Contract #: 04-0120F4Cty: SF/ALA Rte: 80 PM: 13.2/13.9File #: 69.25B**QUALITY ASSURANCE -- NON-CONFORMANCE REPORT****Location:** Changxing Island, Shanghai, P.R. China**Report No:** NCR-000966**Prime Contractor:** American Bridge/Fluor Enterprises, a JV**Date:** 11-Jan-2011**Submitting Contractor:** Zhenhua Port Machinery Company, Ltd (ZPMC), Changxing Island**NCR #:** ZPMC-0925**Type of problem:****Welding****Concrete****Other****Welding****Curing****Procedural****Bridge No:** 34-0006**Joint fit-up****Coating****Other****Component:** Bikepath BK4A and BK6A**Procedural****Procedural****Description:**

Reference Description: The dimension and location of the slotted holes were not built per the approved shop drawings on the Bikepath bearing plates

Subject: NCR No. ZPMC-0925

Contract #: 04-0120F4Cty: SF/ALA Rte: 80 PM: 13.2/13.9File #: xx.25A**QUALITY ASSURANCE -- NON-CONFORMANCE RESOLUTION****Location:** Changxing Island, Shanghai, P.R. China**Report No:** NCS-000925**Prime Contractor:** American Bridge/Fluor Enterprises, a JV**Date:** 07-Feb-2011**Submitting Contractor:** Zhenhua Port Machinery Company, Ltd (ZPMC), Changxing Island **NCR #:** ZPMC-0925**Type of problem:**

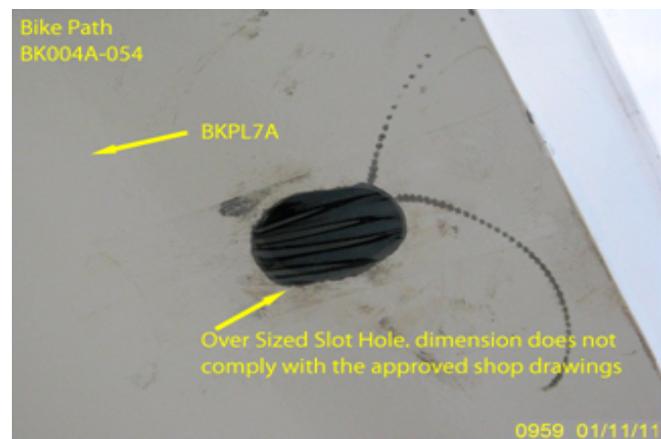
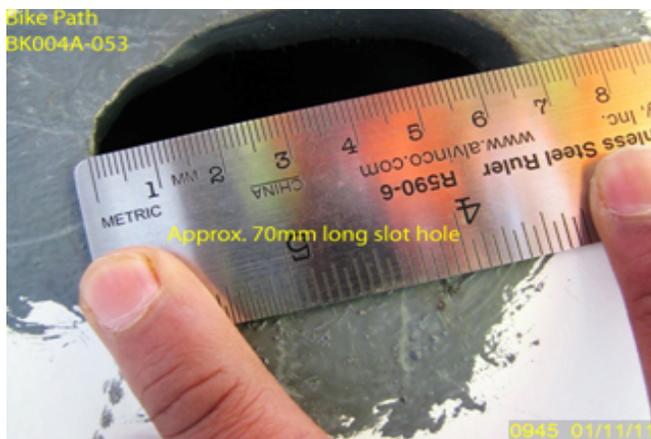
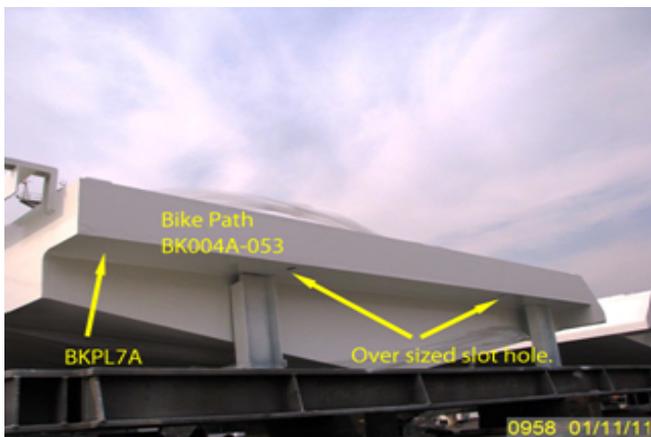
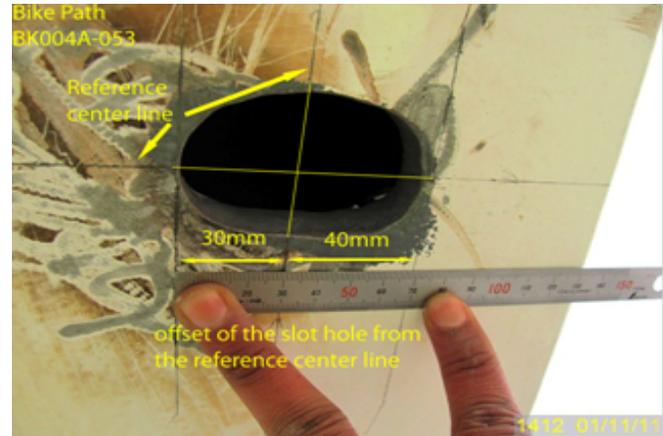
During Quality Assurance (QA) dimensional check of the bearing plate slotted holes on the Bikepath for final Green Tag Procedure, this QA inspector discovered the following issues:

- The measured slotted holes dimensions on the bearing plates (BKPL7A for BK4A and BKPL14A for BK6A) of the Bikepaths do not comply with the approved shop drawings.
- The affected Bikepath components are identified as: BK004A-001, BK004A-003, BK004A-004, BK004A-005, BK004A-008, BK004A-009, BK004A-010, BK004A-012, BK004A-017, BK004A-019, BK004A-020, BK004A-021, BK004A-026, BK004A-053, BK004A-054, BK004A-056, and BK006A-002.
- The slotted holes dimensions measured approx. 68~72 mm long and 40~45mm wide.
- Some slotted holes are offset from the correct locations (see the identified reference line in one of the pictures below)

Per TC RFI-0314R0, the oversized holes documented in this NCR are fit for purpose, based on this ZPMC requests closure of this NCR

This proposed resolution is acceptable. This issue has been addressed by TC RFI-0314R0 and the Department concurs that Non-Conformance ZPMC-0925 is closed.

Contractor submitted TC-RFI 314R0. The Department accepted the as built over-sized holes as Fit-for-Purpose.
